Before the Board of Inquiry
Waterview Connection Project

Rebuttal evidence of **Robert Mason (Design Manager)** on behalf of the **NZ Transport Agency**

Dated: 2 February 2011

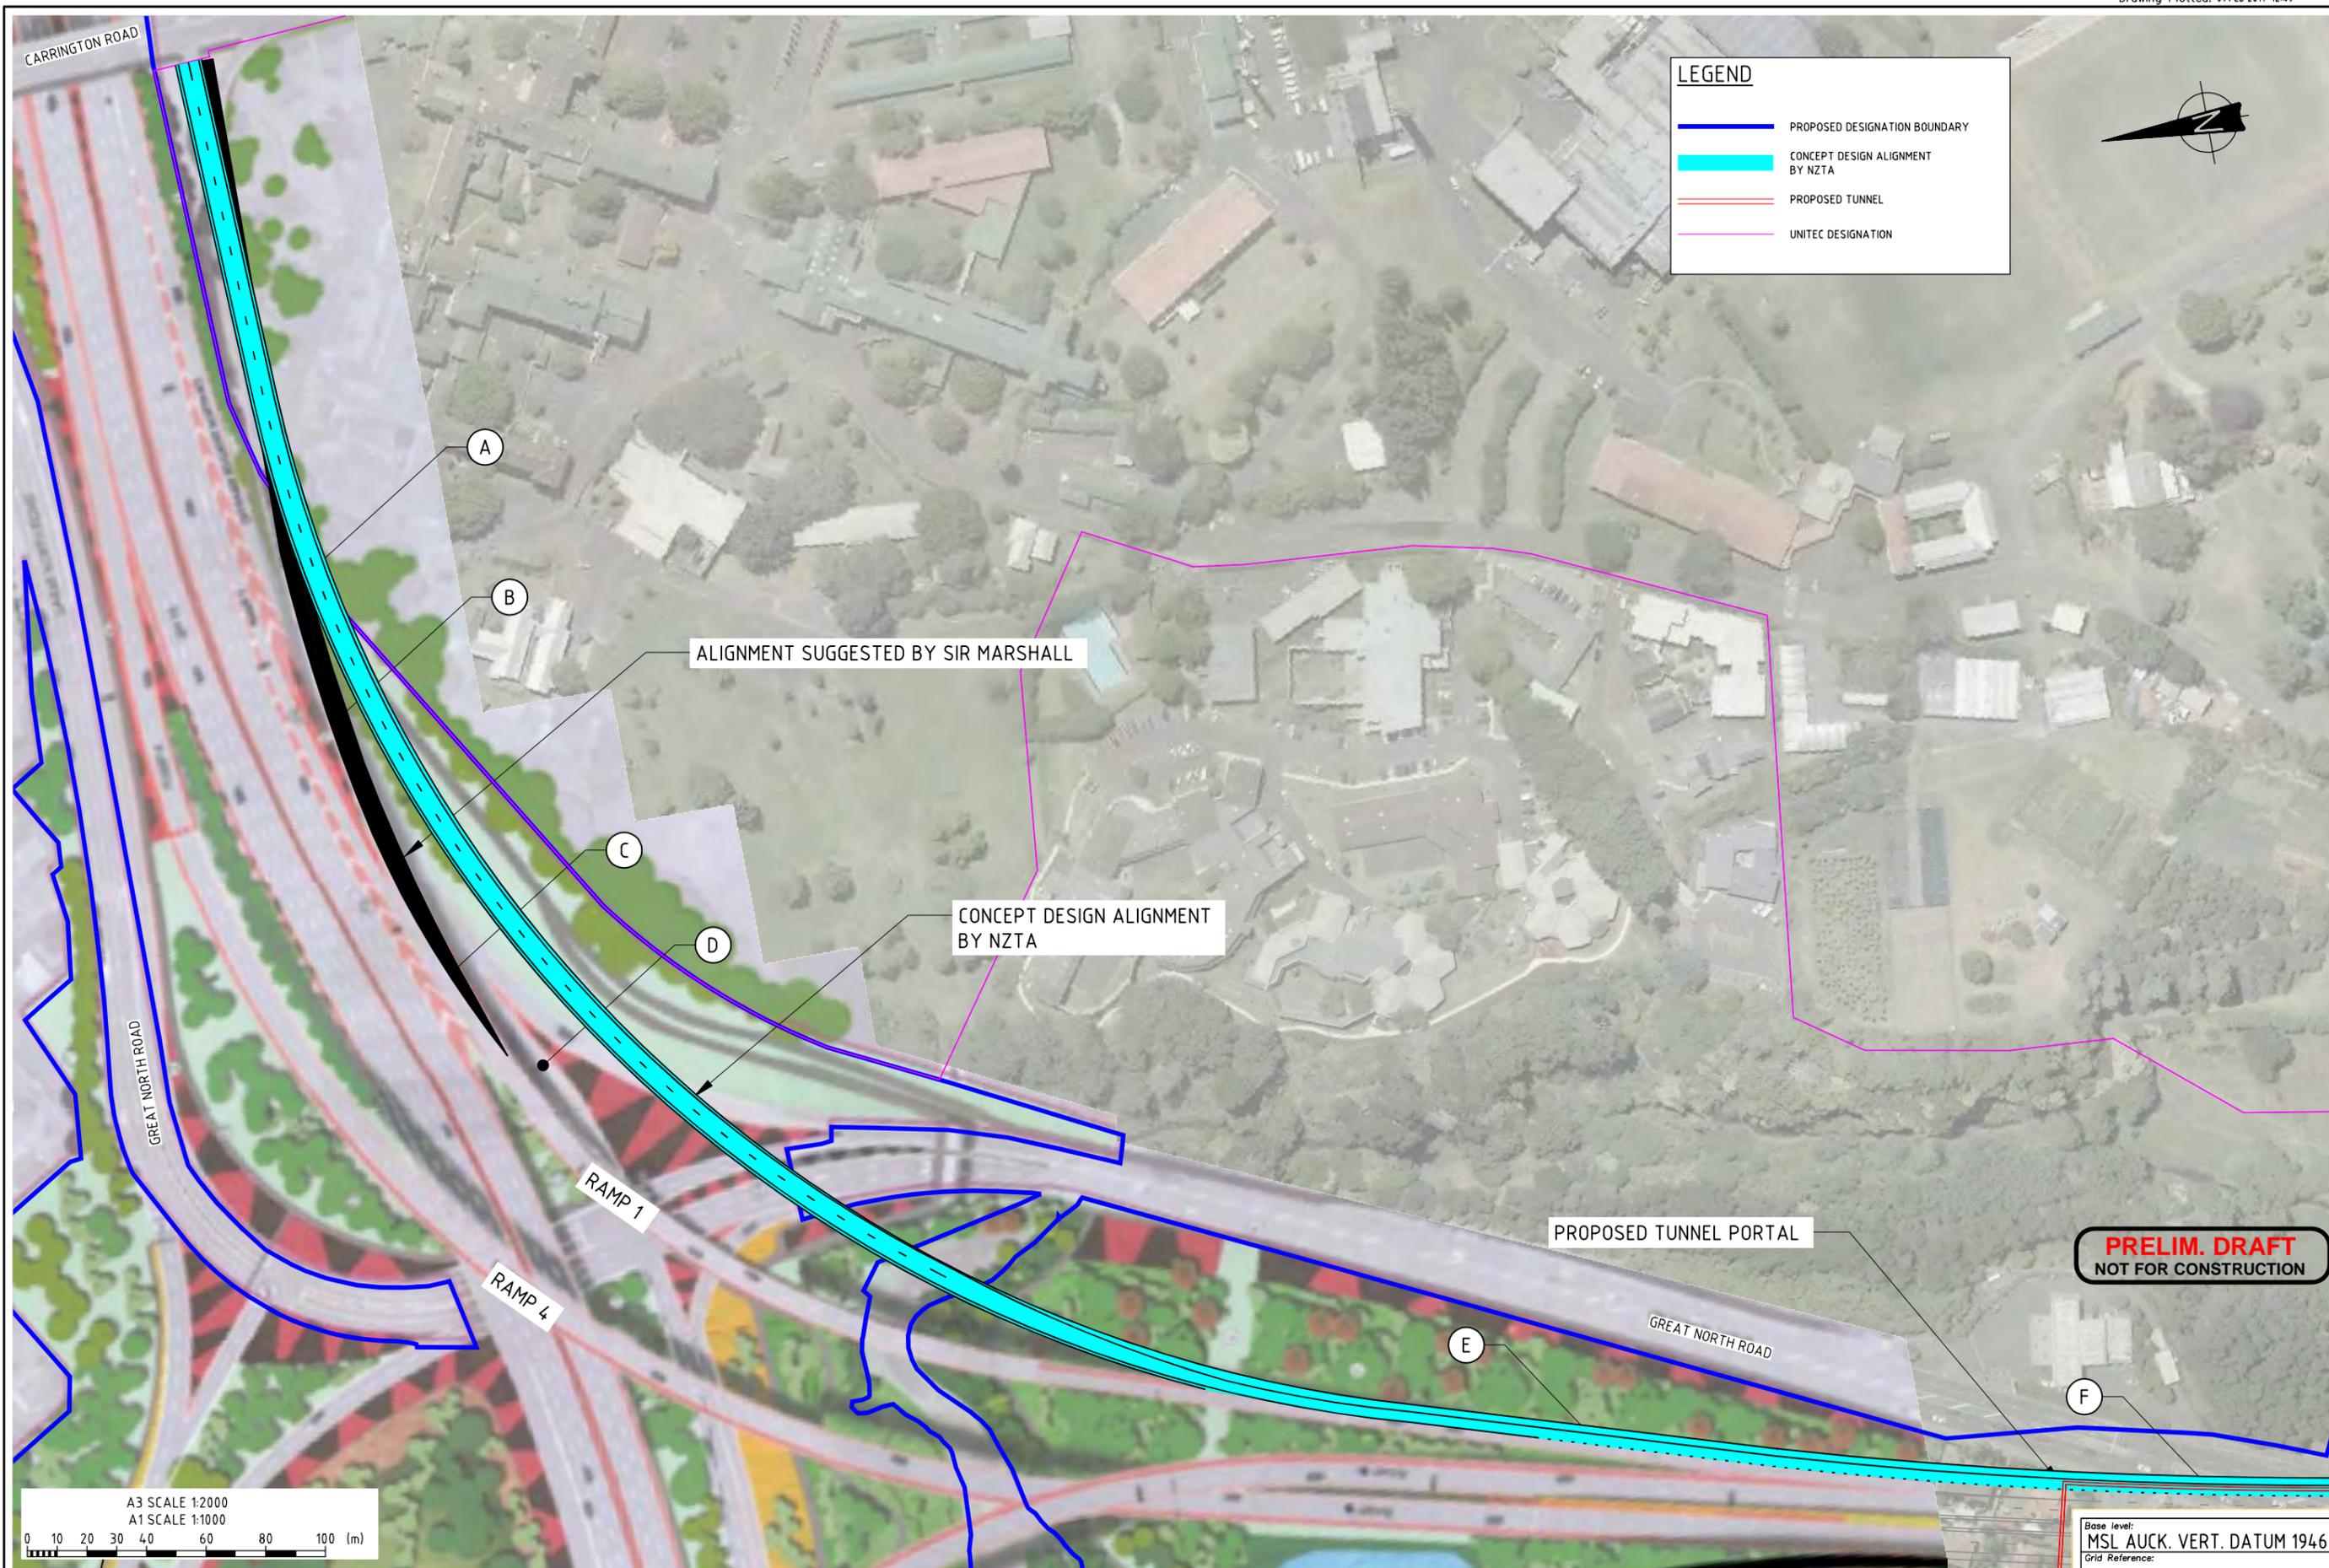
- 50 However, in order to provide sufficient traffic capacity, the NZTA's proposed design includes a two lane connection from the west (being Ramp 3).³⁵ Therefore, I consider that with a two lane connection to the SH20 tunnel from SH16 west, the ramp suggested by Sir Harold would need to merge with the westbound connection from SH16 to SH20 southeast to form three lanes within the tunnel (as indicated by point 'F' on **Annexure C**).

- 51 There are a number of design reasons why Sir Harold's proposed on ramp is not feasible, as follows:
- 51.1 The vertical clearance required dictates the location where the suggested Carrington Road on ramp could first clear the SH16 westbound off ramp to Great North Road. This clearance cannot be provided until approximately 350m from Carrington Road (indicated by point 'D' on **Annexure C**). This compares to the approximately 220m as shown in the paragraph 22 of Sir Harold's evidence, which I disagree with (indicated by point 'B' on **Annexure C**).

- 51.2 The on ramp alignment suggested by Sir Harold would tie in with the proposed connection from SH16 (east) to SH20 (being Ramp 1) on the inside of a low radius curve (indicated by point 'C' on **Annexure C**). However, where this occurs, it would be difficult for an entering driver on the ramp to see approaching vehicles because of the observation angle. It would also be difficult for the entering driver to judge the length of approaching multi combination vehicles,³⁶ both resulting in increased accident risk. To avoid this, the merge area would need to be located on the straight alignment further to the south than that suggested by Sir Harold (indicated by point 'E' on **Annexure C**).

- 51.3 To achieve a ramp merge at the location suggested by Sir Harold, the existing retaining wall at the Unitec property would need to be reconstructed, as the existing wall does not permit a vertical alignment that would allow sufficient sight distance to the merge area. (See **Annexure C**) This would have impacts on the Unitec Heritage Building 1.

- 51.4 The on ramp suggested by Sir Harold would require provision of a compound curve (i.e. two adjoining curves with different radii **as indicated by point 'A' on Annexure C**, which in this case would result **in a 'tightening' alignment at the location** where drivers will be merging with traffic approaching from an acute angle behind them). This would create a safety problem thereby increasing the risk of loss of control crashes.

**ANNEXURE D – SH20 CARRINGTON ROAD SOUTHBOUND ON RAMP:
CONCEPT DESIGN**

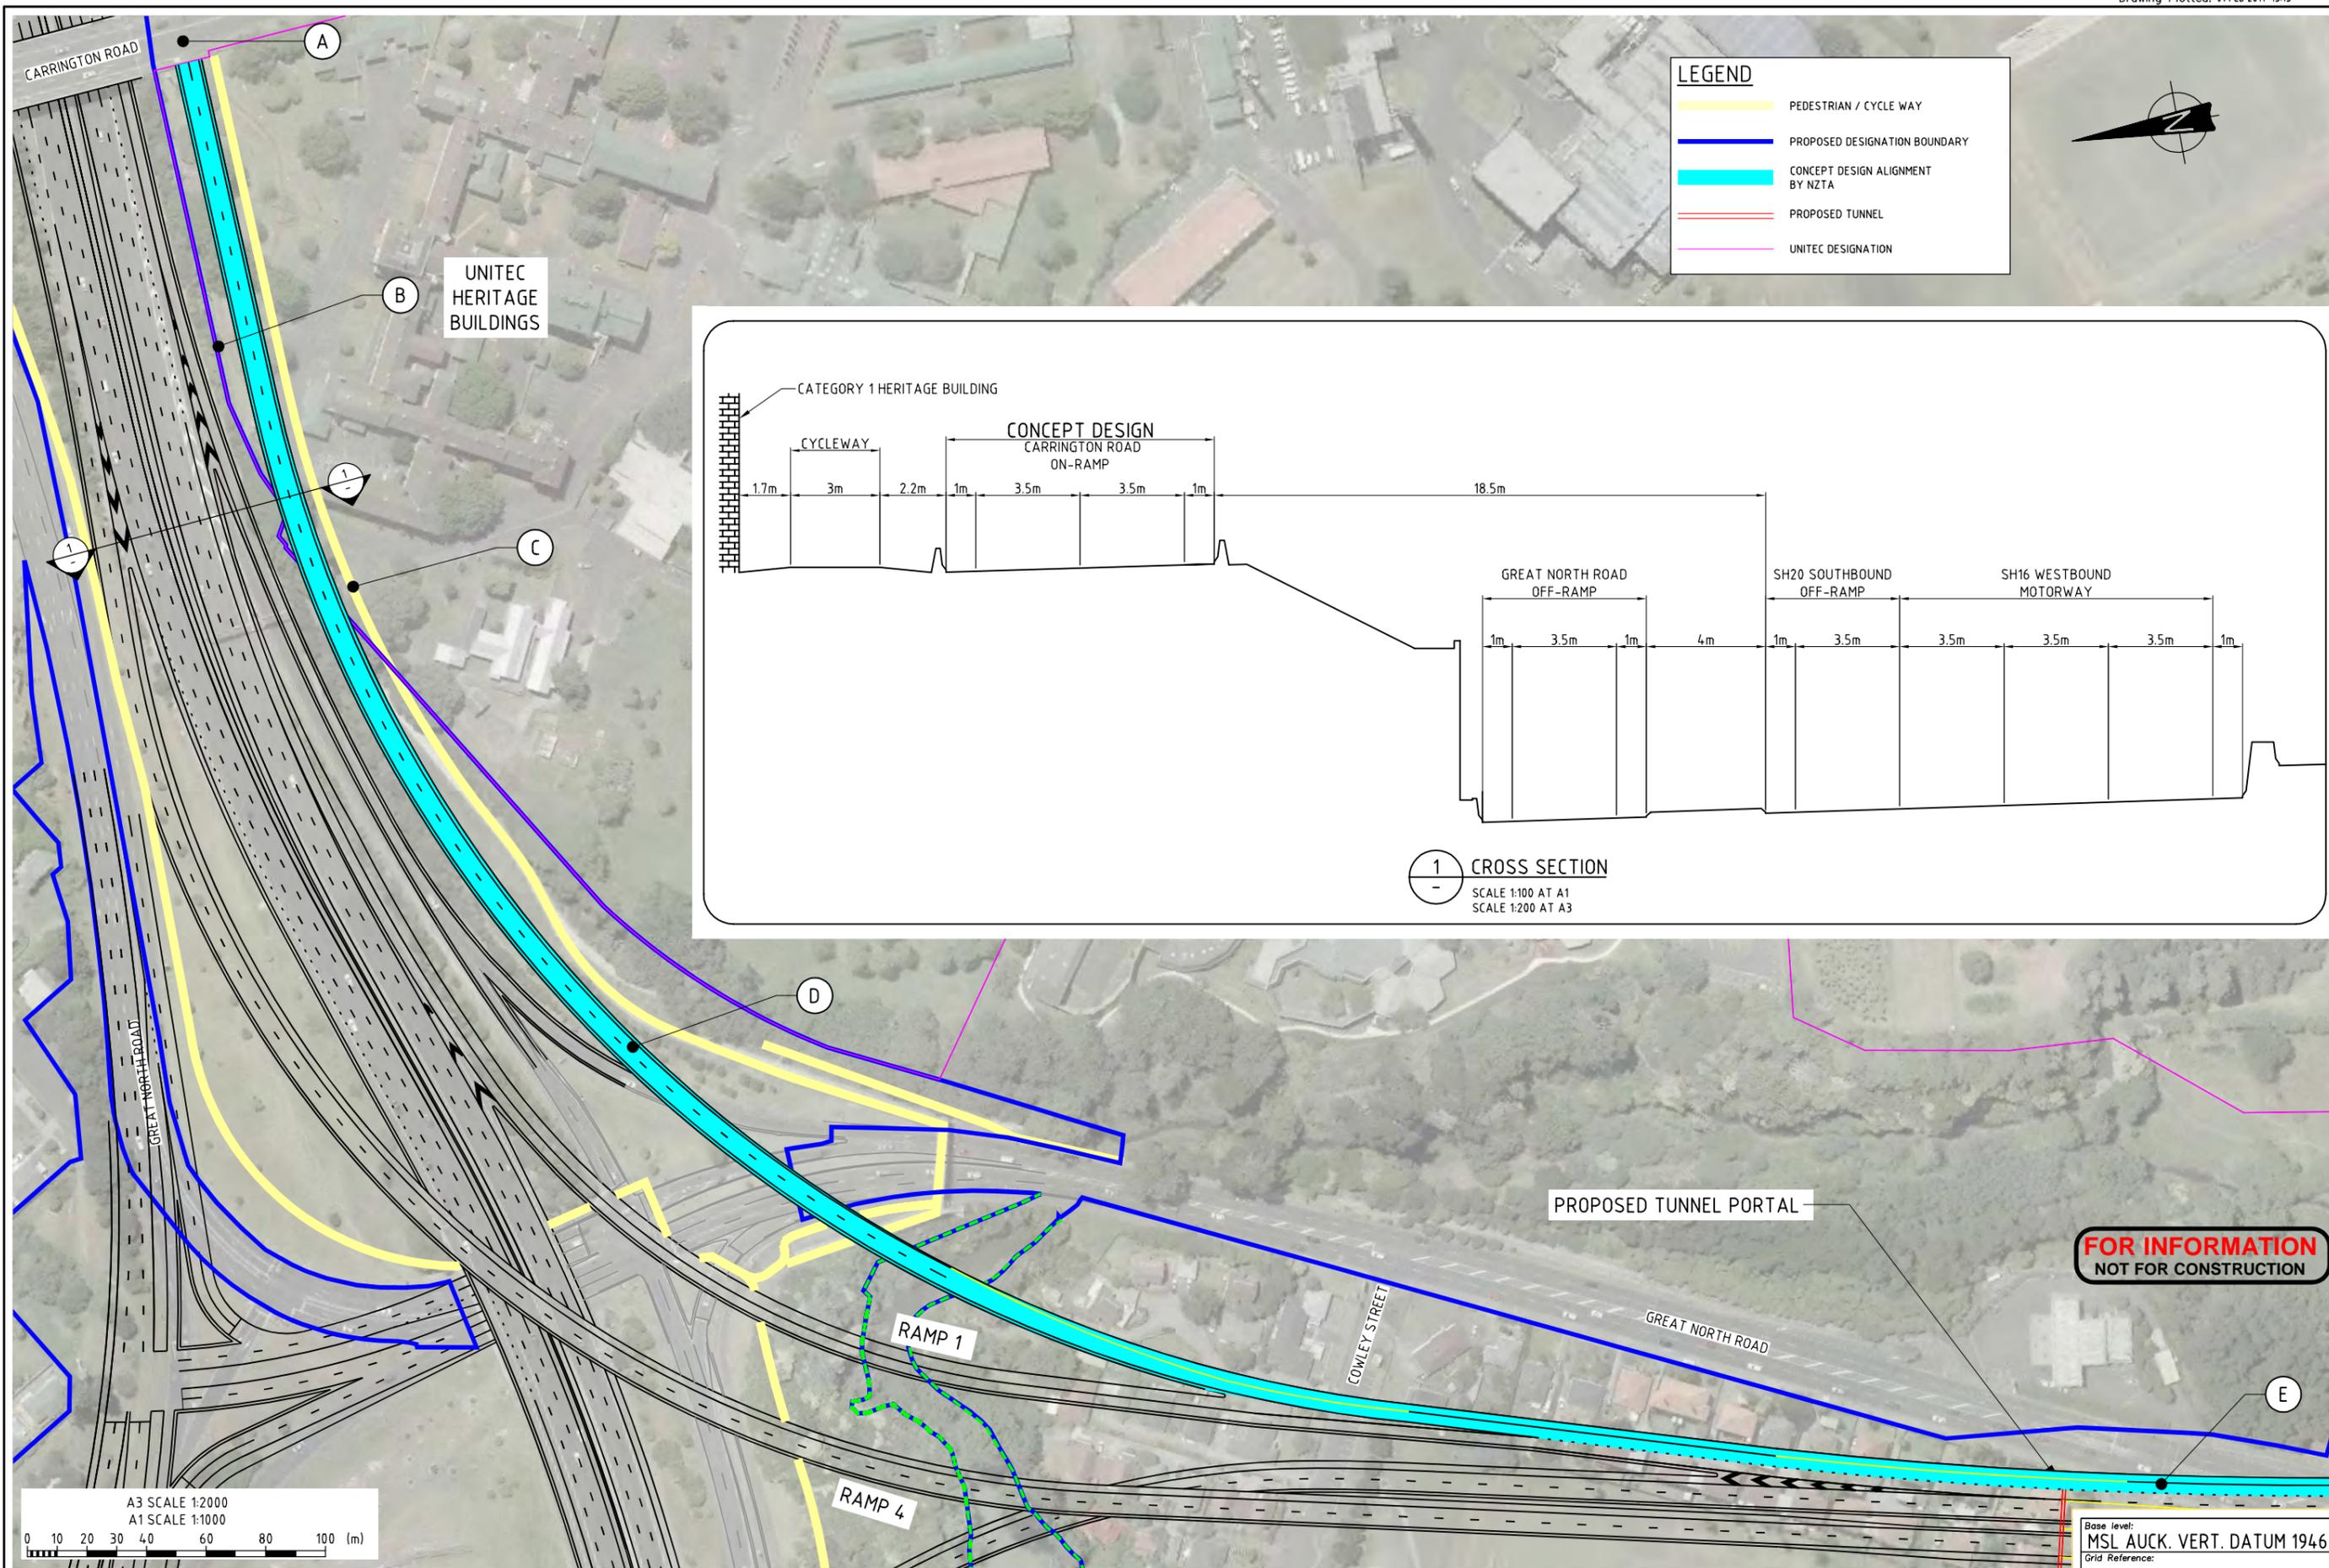
- 54.1 The operation of an intersection on Carrington Road at this location is likely to be inefficient without considerable upgrade to Carrington Road, and the operation of the adjacent Great North Road intersection will be impacted.³⁹ (indicated by point 'A' on **Annexure D**).

- 54.2 The location where the Carrington Road on ramp joins the ramp from SH16 east is positioned adjacent to the ramp connection from SH16 west. I consider this to be unacceptable on safety grounds, as it is likely to cause drivers to fail to notice a lane change taking place on one side while attempting to merge on the other side, resulting in 'sideswipe' crashes.

- 54.3 The merge area for the ramp would occur within the tunnel portal (indicated as point 'E' on **Annexure D**). This results in an increased risk of an accident associated with the merge movement at a location where the changing environment of entering a tunnel places a higher demand on the driving task. On sections of motorways in Auckland, crash studies have shown that there is a greater incidence of crashes associated with merge and diverge areas than the sections between interchanges.⁴⁰

- 54.4 As noted earlier, the provision of a local connection at Carrington Road would need to encroach on the designation for the Unitec property by approximately 10m (as indicated by point 'B' on **Annexure D**), and would be located within 7m of Building 1, (which is a Category A Heritage Building).

- 55 Accordingly, there would, in my opinion, be significant design and safety issues associated with the concept alignment on ramp shown in **Annexure D** (which seeks to accommodate Sir Harold's
